Service Bulletin

Bulletin No.: 18-NA-210

Subject: High Pitch Whine Noise Coming from Front Instrument Panel (IP) Speakers

Brand:	Model:	Model Year:		VIN:		Engine:	Transmission:
		from	to	from	to		
Chevrolet	Equinox	2018	2024	—	—	—	—
GMC	Terrain

5112945

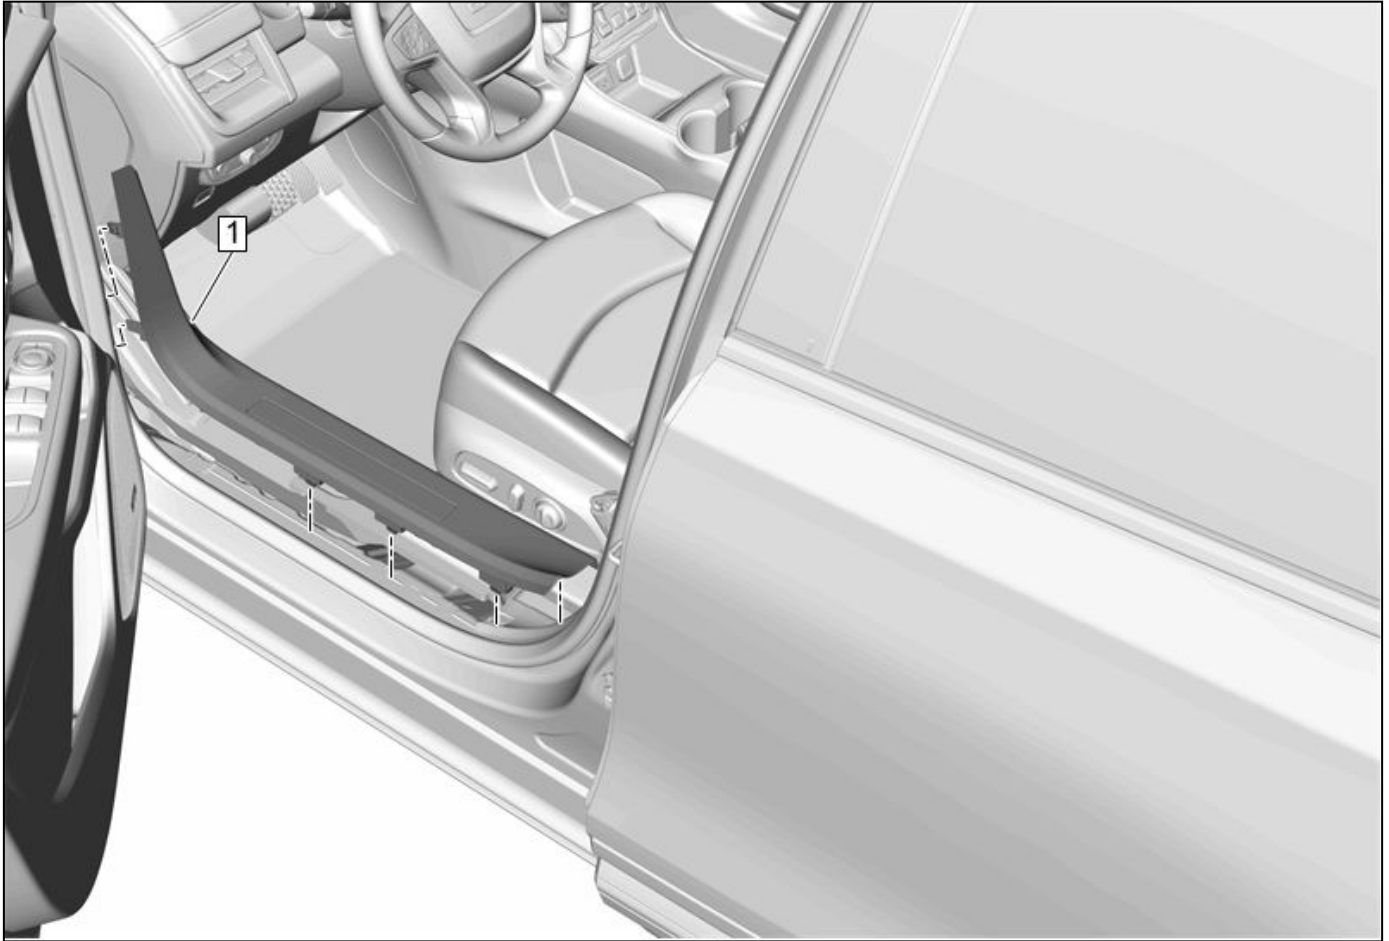
Important: Performing this repair will eliminate the 2173 circuit wire from the IP wiring harness and bypass it directly to the body side harness, as shown in green in the schematic above.
